Proposal for a Supplement to the 03 series of amendments to UN Regulation No. 58

The text reproduced below was prepared by the expert from the International Organization of Motor Vehicle Manufacturers (OICA) to introduce the aerodynamic device in the UN Regulation No. 58. Aerodynamic devices at the rear end of the vehicle shall not compromise the functionality of rear underrun protection devices. The modifications to the current text of UN Regulation No. 58 are marked in bold for new or strikethrough for deleted characters.

Figure 1

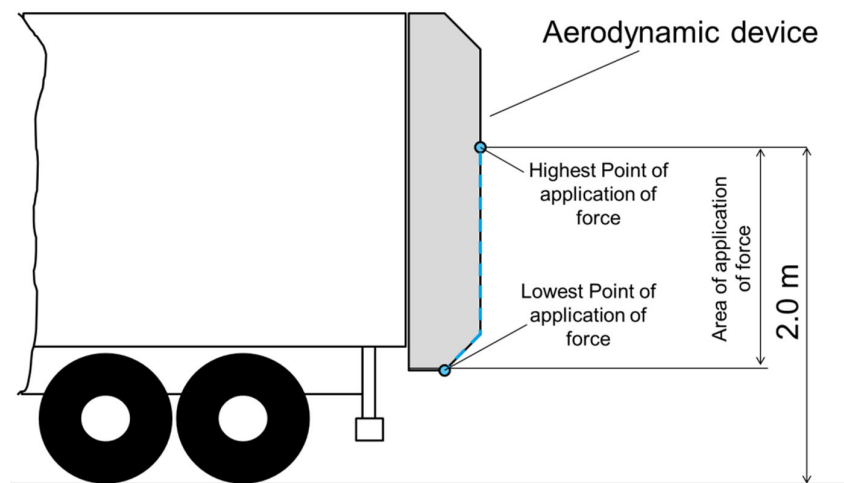
- 5.1.1. A force shall be applied parallel to the longitudinal axis of the vehicle via a surface not more than 250 mm in height and 200 mm wide with a radius of curvature of 5 ± 1 mm at the vertical edges or an adaptor. The surface or adaptor shall not be rigidly fixed to the aerodynamic device and shall be articulated in all directions. When the test is carried out on a vehicle the height of the centre of the surface or adaptor shall be defined by the manufacturer in an area between the lowest edge of the aerodynamic device and a point no more than 2.0 meters above the ground in vehicle-mounted condition (see figure 1). This point is to be defined on a laden vehicle with the technically permissible maximum laden mass.

Figure 2

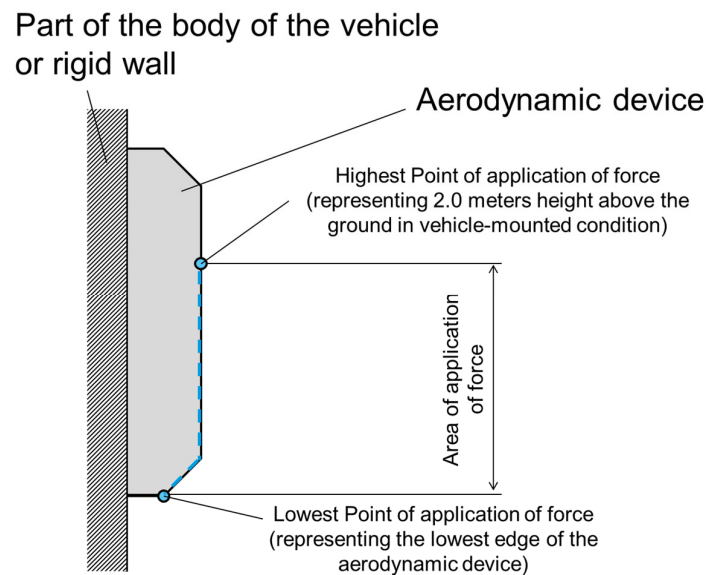
When the test is carried out on a part of the body of the vehicle type or on a rigid wall the height of the centre of the surface or adaptor shall be defined by the manufacturer in an area between the lowest edge of the aerodynamic device and the point that represents the height of no more than 2.0 meters above the ground in vehicle-mounted condition on a laden vehicle with the technically permissible maximum laden mass (see figure 2).

Figure 3

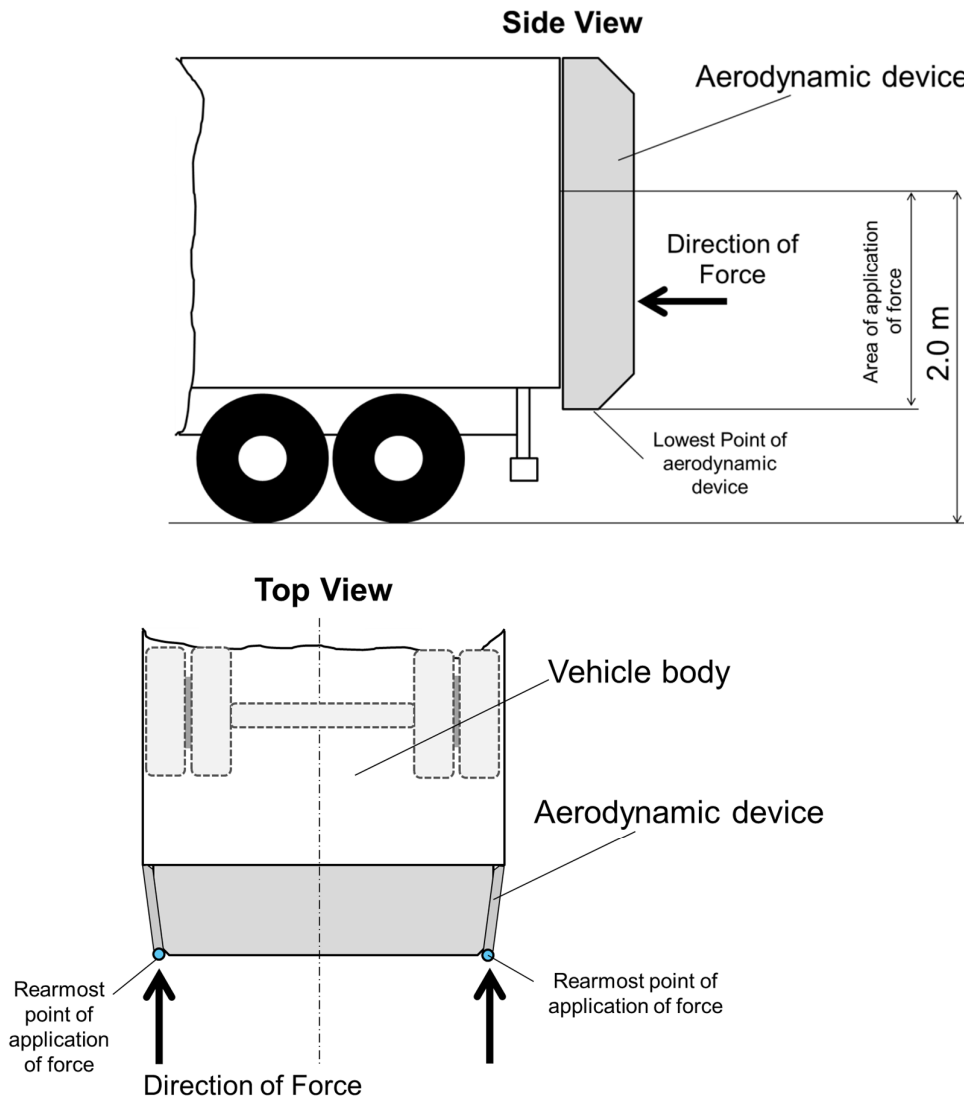
5.1.2. A horizontal force of maximum $[4000] \text{ N} \pm 400 \text{ N}$ shall be applied consecutively to two points situated symmetrically about the centre line of the vehicle or the centre line of the device on the rearmost outer edge of the aerodynamic device in completely unfolded or not retracted condition (see figure 3). The order in which the forces are applied may be specified by the manufacturer.

Figure 4

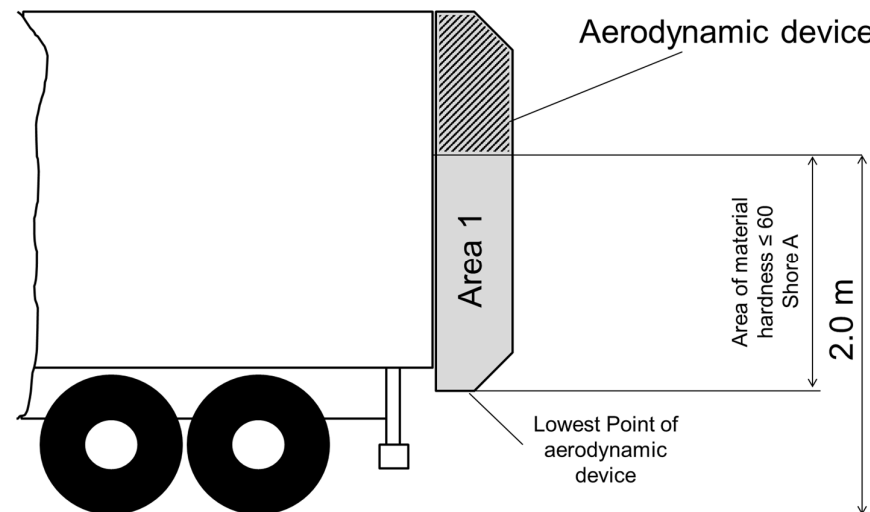
- 6.2 Notwithstanding the provisions in paragraph 5.1., 5.1.1., 5.1.2. and 6.1 the application of forces shall not be conducted if the aerodynamic device is made of a material of hardness not exceeding 60 shore A in the area 1 regarding figure 4. Components (fastenings, hinges, actuators, springs, cables, lamps etc.) used to install the aerodynamic device on the body of the vehicle or that are mounted on the aerodynamic device are exempted from these provisions.
